# Responses to CEC Data Requests Set Four: Nos. 219 through 244

## Revised Application for Certification (08-AFC-8) for HYDROGEN ENERGY CALIFORNIA Kern County, California

February 2011

California Energy Commission

**FIGURE 219-2**

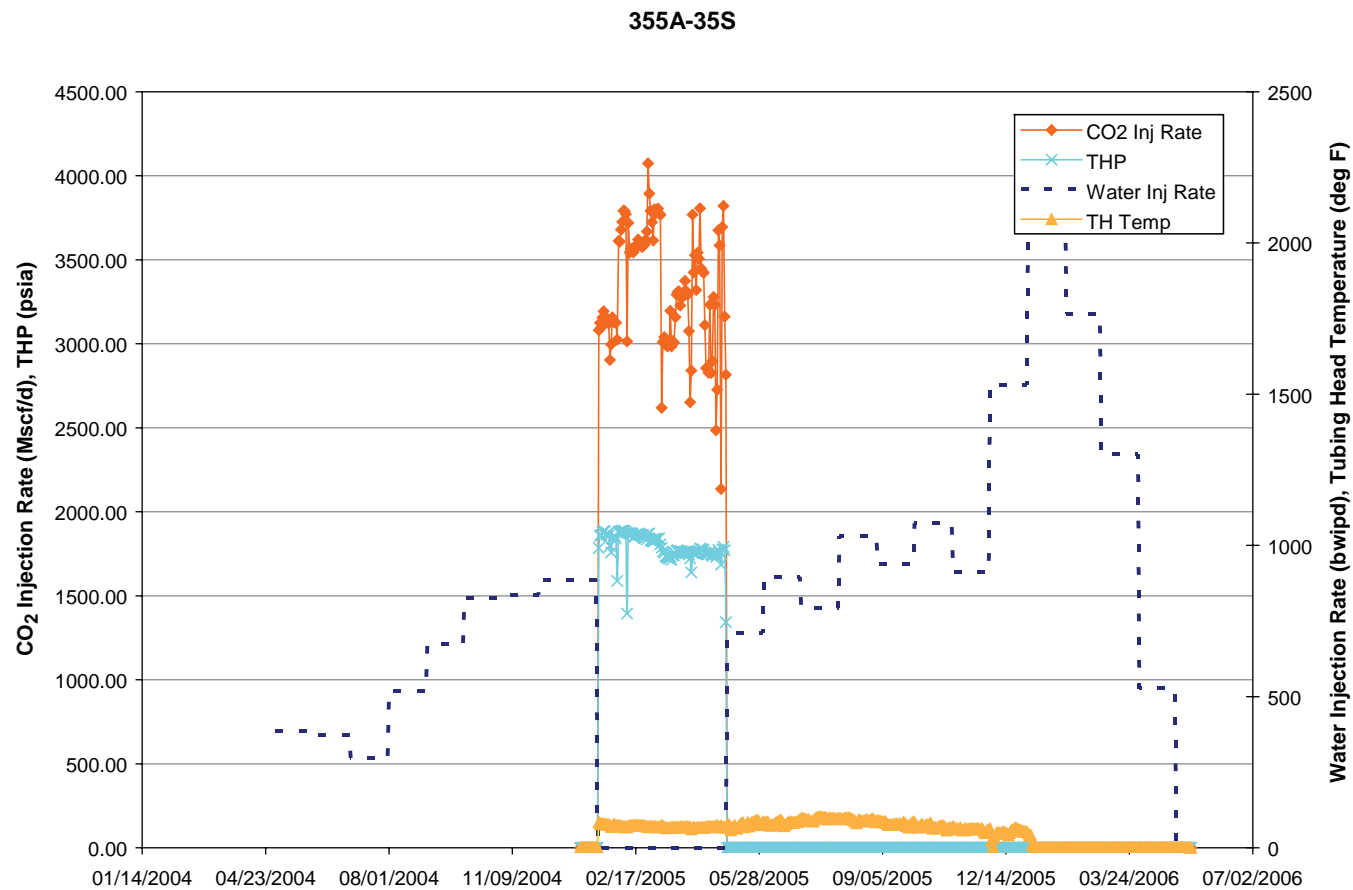
**219. Please provide the OEHI reports detailing the EOR/CCS injection pilot project performance at Elk Hills, especially CO<sub>2</sub> injectivity and estimates of volumetric sweep.**

Injection started on May 1, 2004 with 9 months of brine pre-flush to increase the salinity of the formation water in the pilot area. This pre-flush was necessary to ensure sufficient resistivity contrast between oil and formation water so that saturation changes could be measured. CO<sub>2</sub> injection commenced on January 18, 2005, with the injection rate and tubing head pressures shown on Figure 219-2.

**FIGURE 233-1**

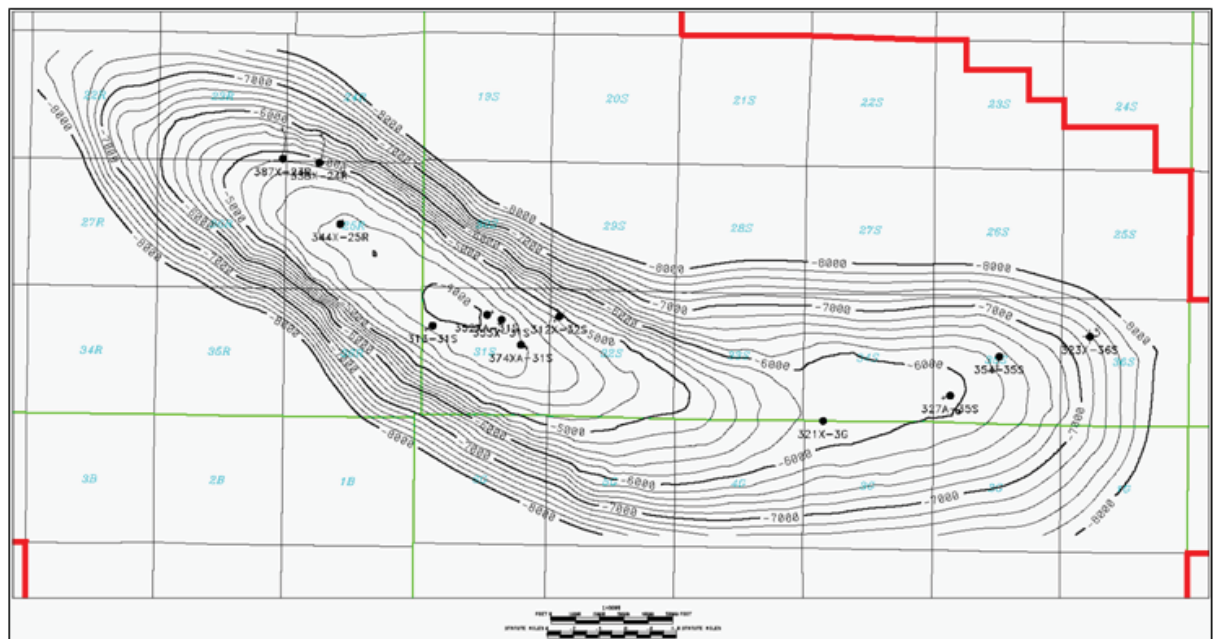
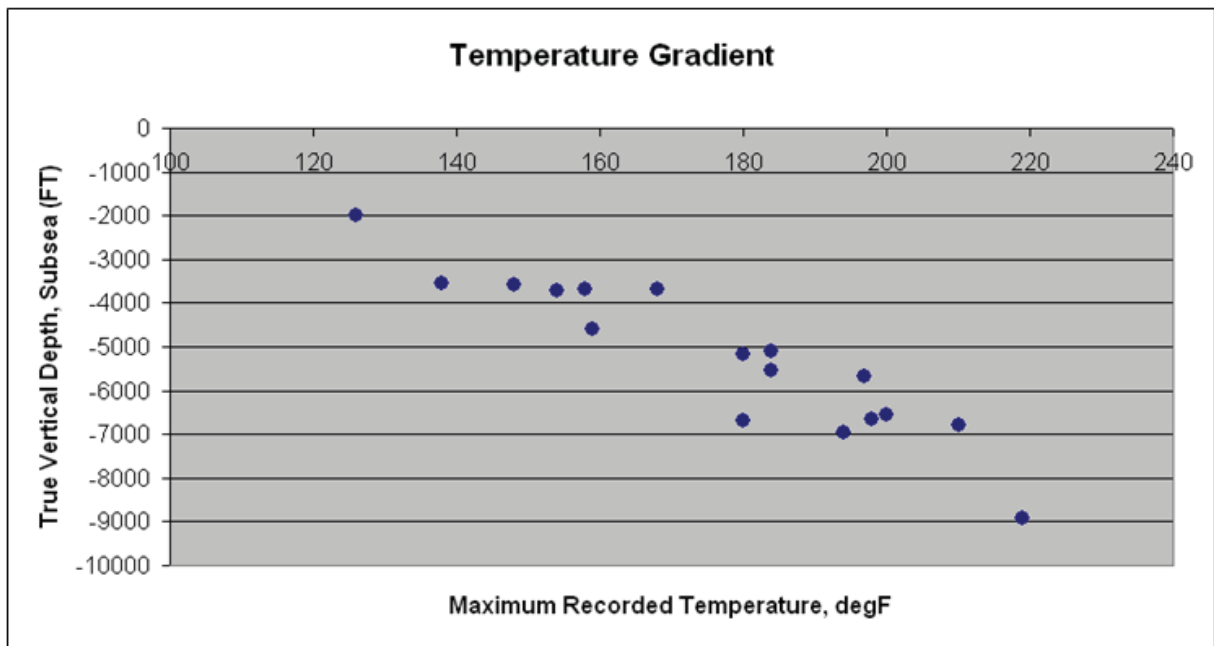
**233. Please provide information on the current reservoir temperature profile, again where and how measured.**

The maximum temperature encountered on a logged well is recorded on the log's well header.

Figure 233-1 indicates the maximum recorded temperature for each corresponding well, along with the location of each well. The plot of those temperatures at different total depths shows the temperature profile.

**FIGURE 240-1**

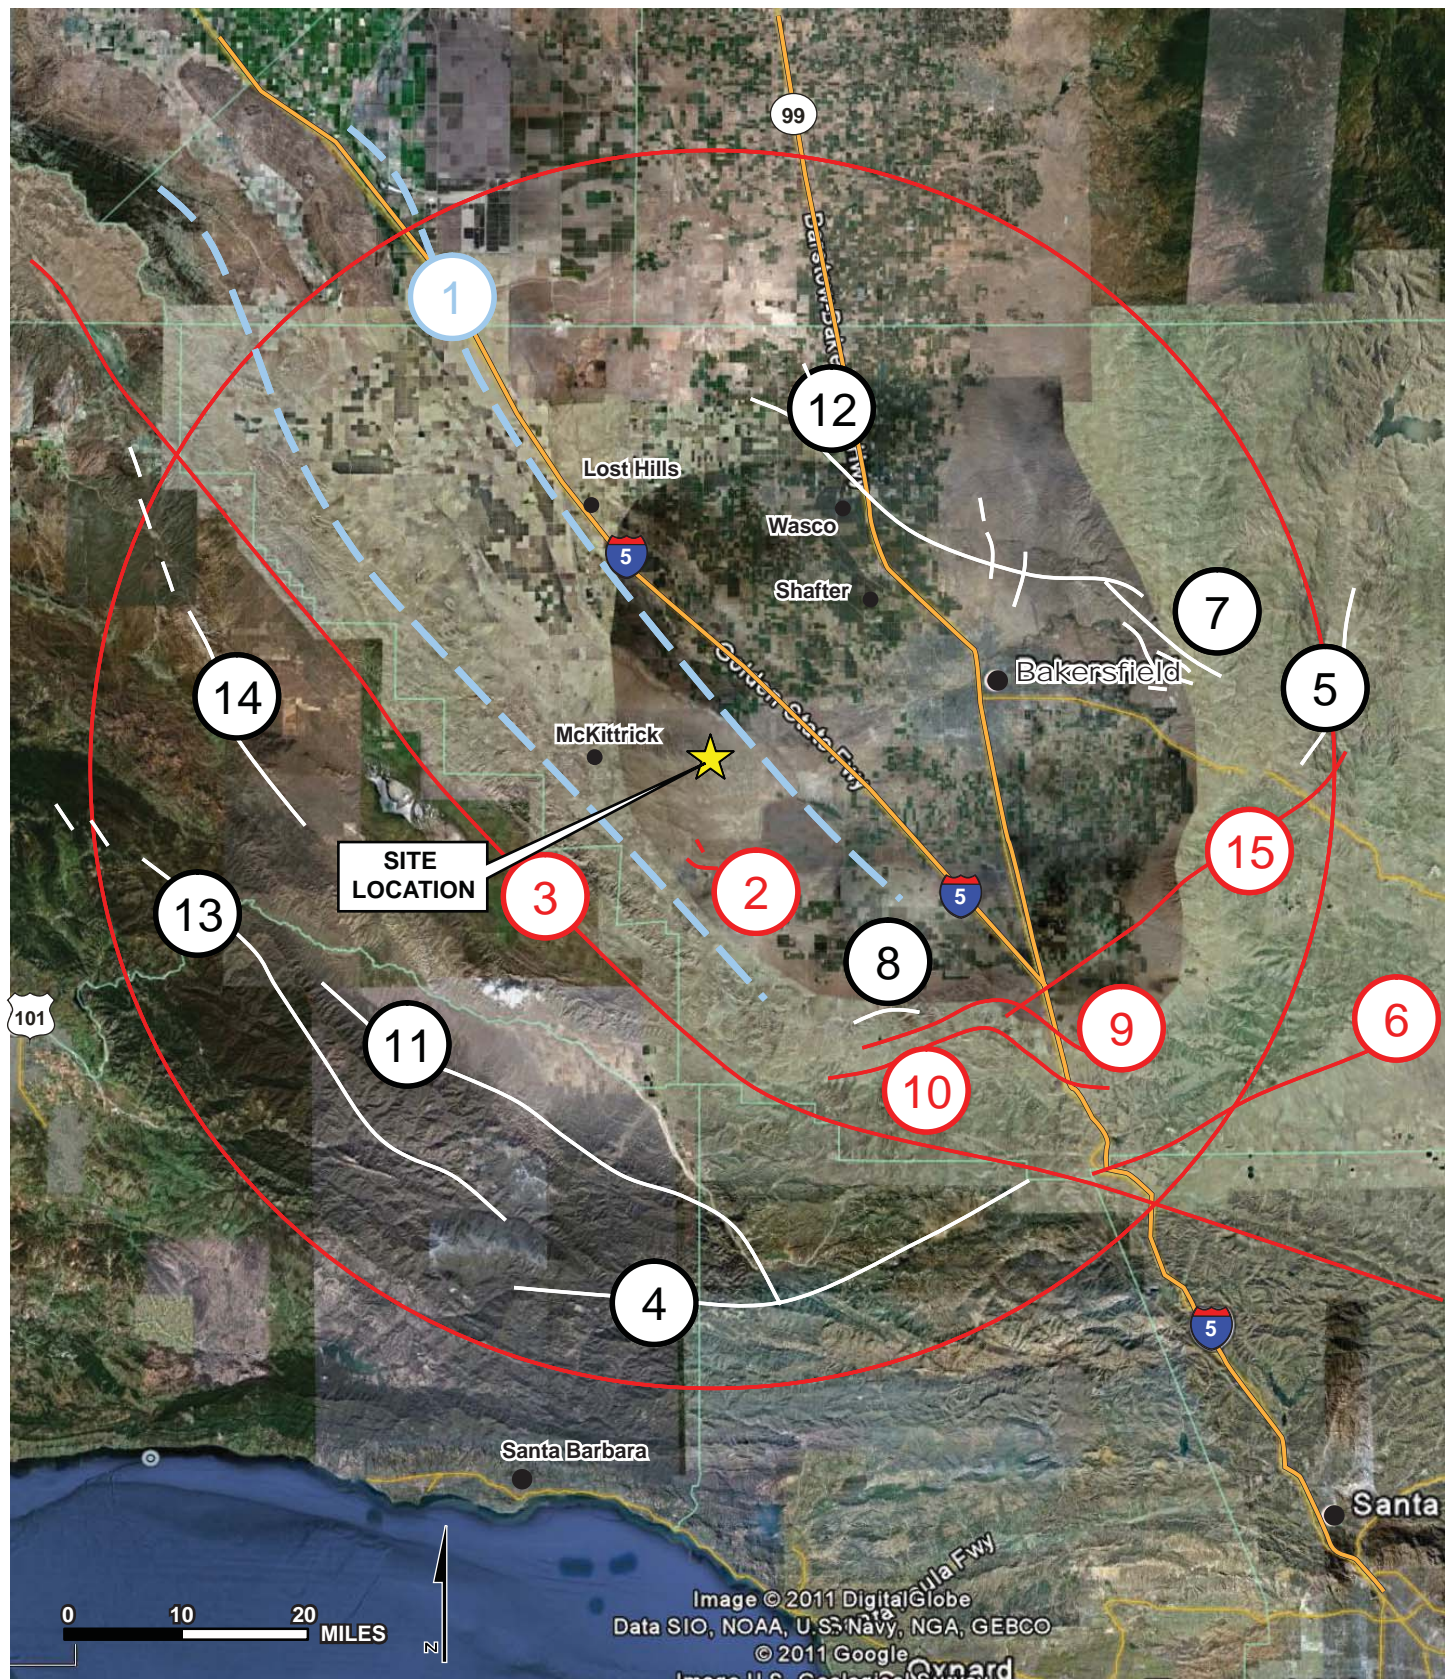
**240. Please provide a map and figures showing the location of active and potentially active faults and time and magnitude of rupture along faults within 50 miles of the project site.**

Figure 240-1 highlights both active and potentially active faults within 50 miles of EHOE.  
Table 240-2 lists these faults along with an estimated range of maximum magnitude and the date and location of the last known event.

**FIGURE 241-1**

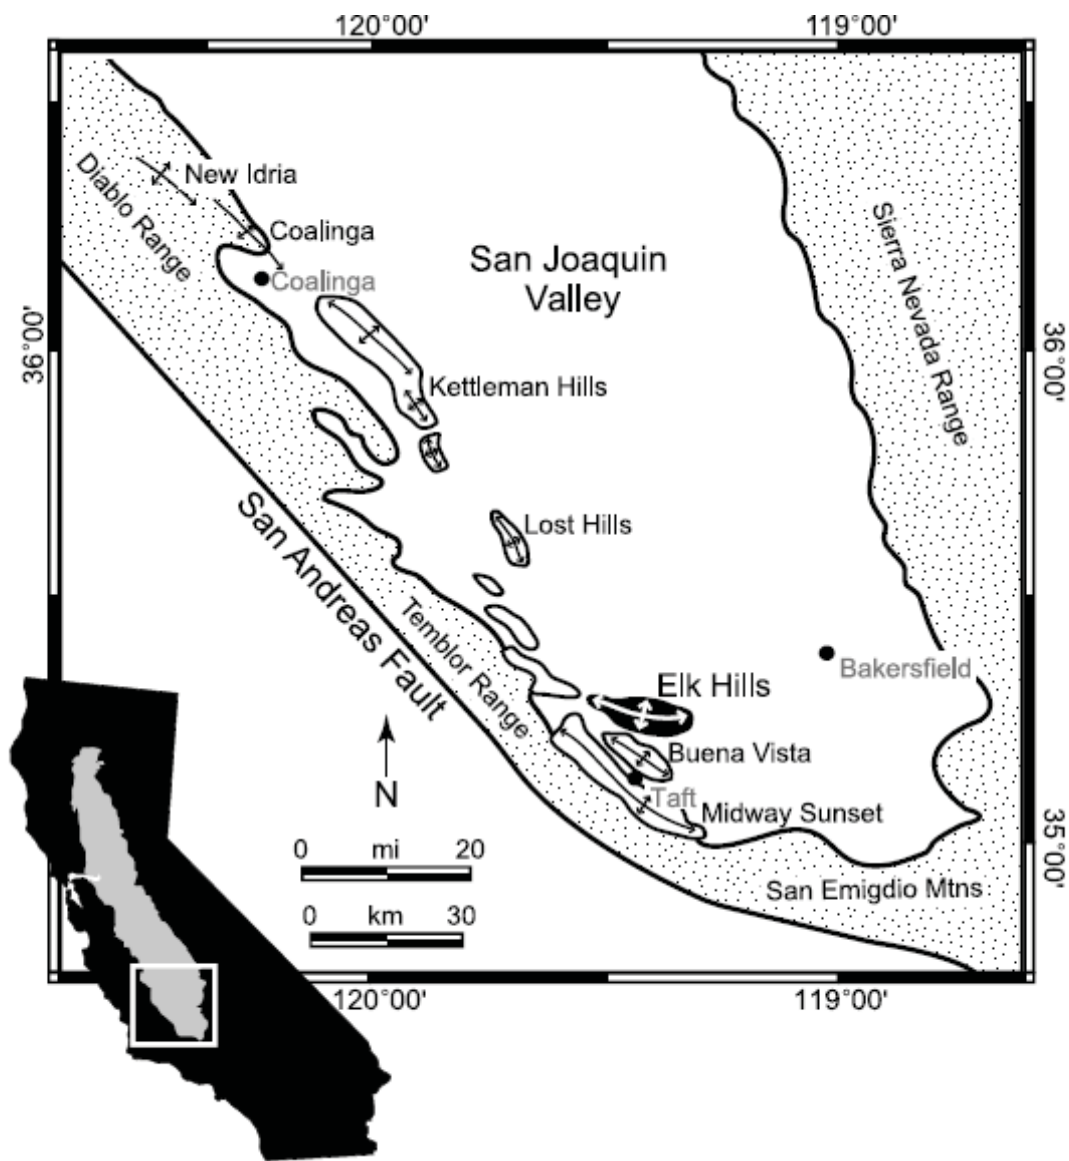
**241. Please provide an analysis of the tectonic framework of the anticline and how it fits within the regional tectonic framework proximal to the San Andreas Fault.**

Elk Hills is located 25 kilometers (15.5 miles) north of the bend in the San Andreas fault (Figure 241-1) in the southern San Joaquin Valley within the fold and thrust belt that lines the west side of the valley (Nicholson, 1990). The deformation within this belt is linked to tectonism along the San Andreas fault, which lies just west of the Temblor Range that bounds the western limit of the valley. Coalinga, Kettleman Hills, and Lost Hills are similarly oriented antiforms proximal to Elk Hills.
